CTL 决议

标准 (包含：年份)	条款	编号	年份
IEC 62368-1:2014 ed.2.0 IEC 62368-1:2018 ed.3.0 IEC 60664-1:2020	附录O	2214	2023
类别			
ITAV

主题	关键词	制定	批准年份
爬电距离和电气间隙的测量	爬电距离 电气间隙	ETF2	2023或2024年CTL全体会议

**Figure O.4 – Intervening unconnected conductive part**

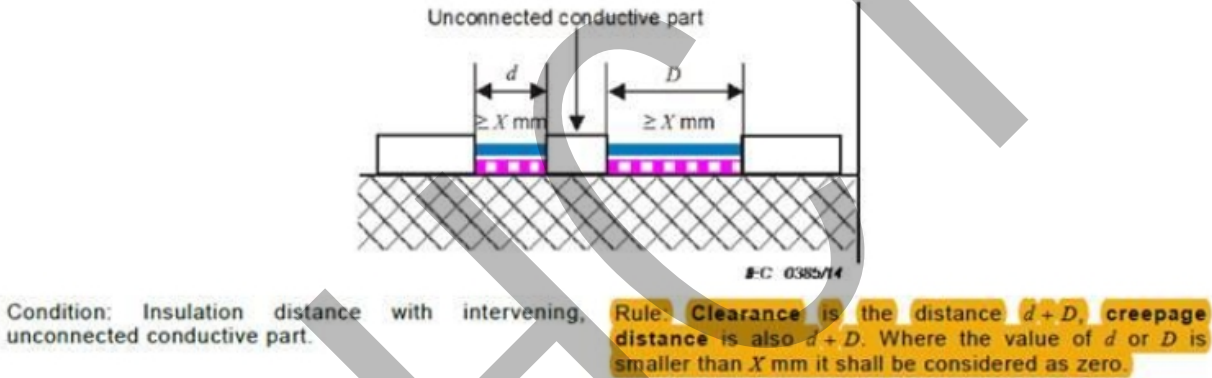
Rule: **Clearance** is the distance $d + D$, **creepage distance** is also $d + D$. Where the value of d or D is smaller than X mm it shall be considered as zero.

如上图所示，在IEC62368-1;2014 ed.2.0附录O中图O.4解释如下：

规则：电气间隙就是d + D，爬电距离也是d + D。如果d或D的数值小于X mm，则该数值应认为是零。

在IEC 62368-1:2018 ed.3.0附录O中，图O.4也是相同表述。

虽然，IEC 60664-1: 2007 和 IEC 60664-1:2020 中，在 IEC60664-1:2007 这个版本中没有表述关于d或D的数值小于X mm的情况。

问题：根据IEC62368-1对于未连接的导电零部件（悬浮导体），应怎样评估电气间隙和爬电距离？

决议
参考 DSH2160。

注释
IEC62368- 1 ed4 中 108 /800/FDIS 草案中图 O.4 有所更改，与 IEC60664-1 的决议 DSH2160 一致。2022 年 11 月 IEC TC108 HBSDT 旧金山：与 OSM EE 文件 22/5 的内容达成一致意见。

NOTE: d < X, D ≥ X, C is conductive floating part
Figure test PCB sample

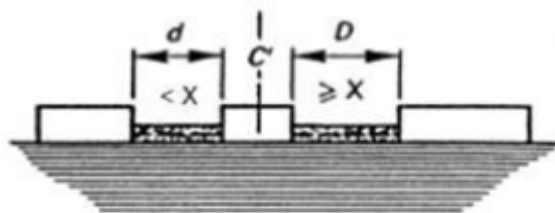
A PCB sample is tested according to sub-clause 6.2 of IEC 60664-1:2007. How to measure creepage distances when the path is split by floating conductive parts when d < X and D ≥ X?

Different interpretations of total creepage distance are as follows:

Opinion 1: The creepage distance is measured as shown in IEC 60664-1:2007 example 11. Creepage distance is the distance = d + D.

Opinion 2: Since the d is less than X, the d is considered as zero. Creepage distance is the distance = D.

Which opinion is correct?

Opinion 1 is correct. Creepage distance is the distance = d + D.
